# Change Order | BCA ARCHITECTS & ENGINEERS Allowance | Pay App **Transmittal**

2023 Capital Outlay Project 2023-008

CO 1-04 Add'l Subbase

Change Order Number: 1-04

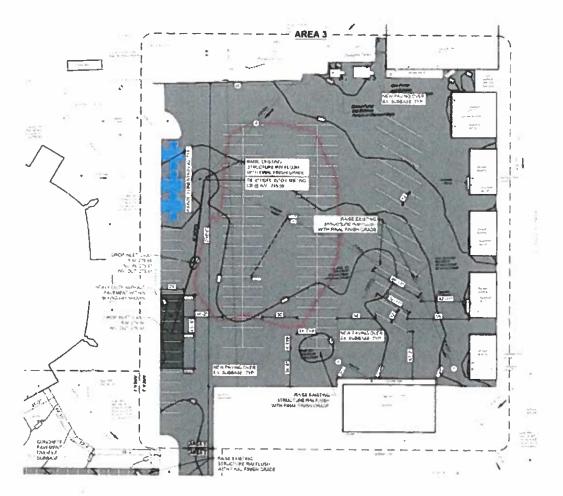
Barret laid out the grades on the existing asphalt area that is low based upon the new grading plan. Below circled in red is a rough sketch of the area in question. Area is roughly 18,000sf at an average of 3" low. Varies from 1-6". We will import additional stone required to meet the new finish grades unless you want to regrade the area. I will have Cliff provide Zach copies of tickets to tally what is added in.

Core No.	Photograph
C-8	CT 4422 C-8 1.50 " Top 3.25 Binder/Base 4.75 "Total Recovery Length

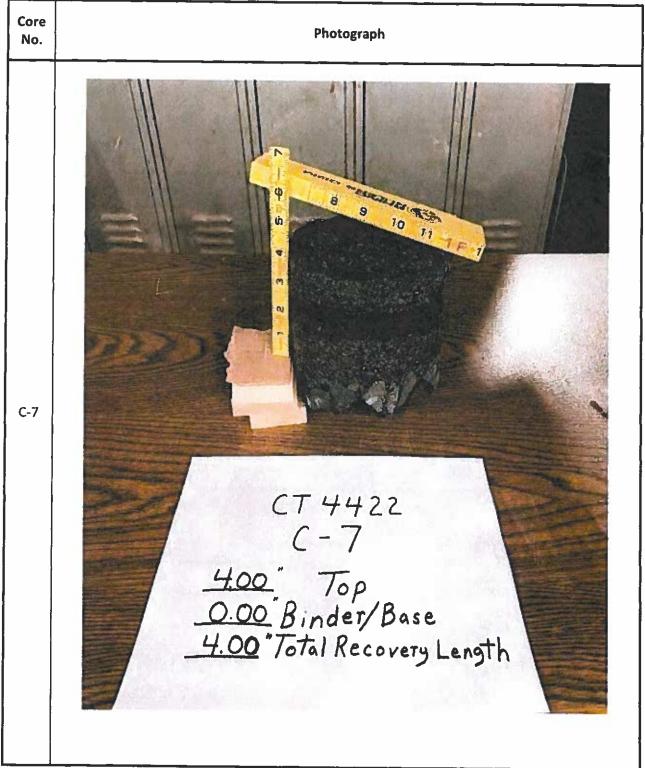
Below please find our proposal to provide additional stone in the area 3 parking lot to meet finish grades. Borings showed existing asphalt thickness to be approximately 3" C8 (4.75"), C9 (3"), C10 (3"), and C11 (2.75) on drawing L100.

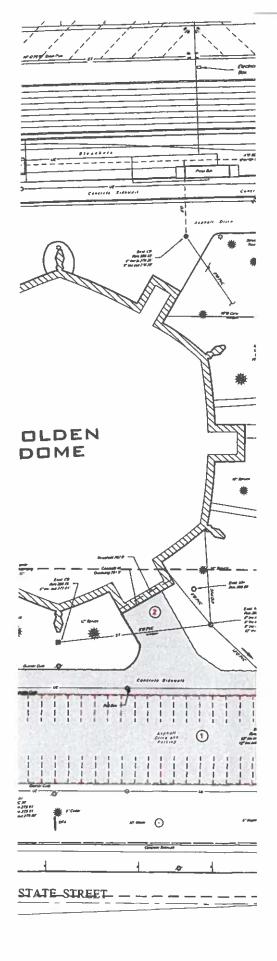
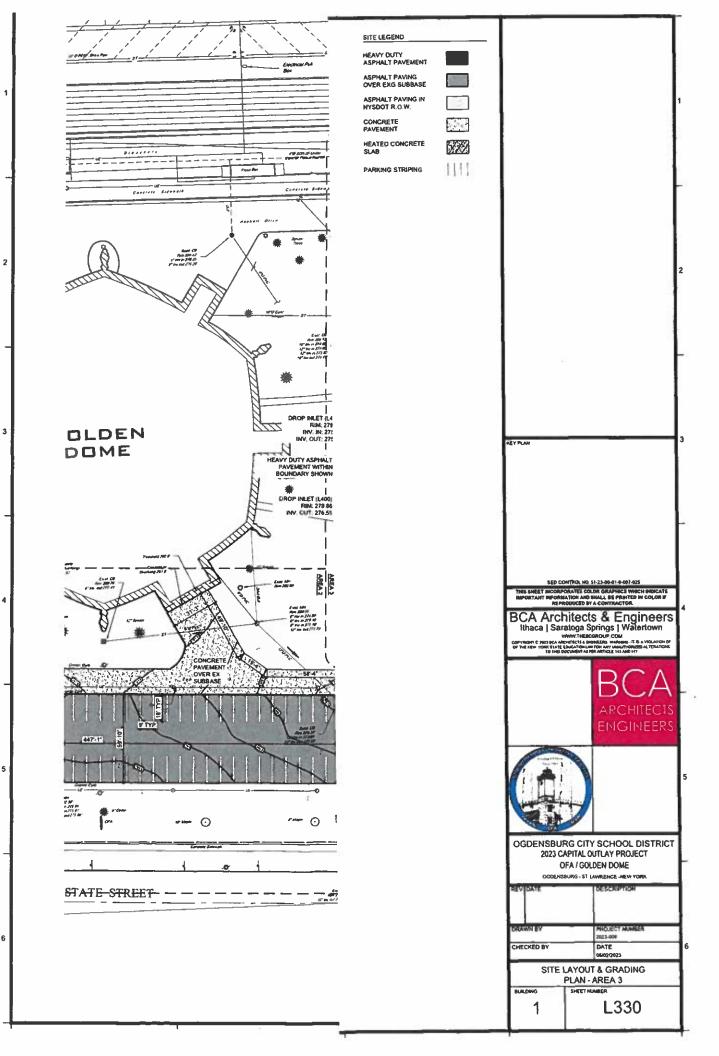
Drawing L230 indicated to remove existing paving leaving existing sub-base material. As the borings indicated removing 3" of paving in most locations and the new section was scheduled to be 5" thick we should have had 1-2" of additional stone to reshape the parking lot with. We did not we imported additional stone on 8/1 and 8/2.

Α	General Contractor
В	Under the Capital Outlay Project, the existing parking lot noted in Area 3 was scheduled for reconstruction as per Contract Drawings L230 and L330.
С	During removals, the General Contractor discovered that the thickness of existing asphalt varied greatly throughout Area 3. Preconstruction borings indicated an existing asphalt depth of 3-inches; while demolition revealed an asphalt section as much as 8-inches. As such, additional subbase material was provided to make up the difference with the new 5-inch pavement section.
D	Add to provide all labor, materials, and equipment for additional 876 tons of compacted subbase required to meet grade as a result of varying thickness in existing asphalt at Area 3.

Add for all labor, material, and equipment to provide additional 876 tons of compacted subbase required to meet grade as a result of varying thicknesses in existing asphalt at Area 3.
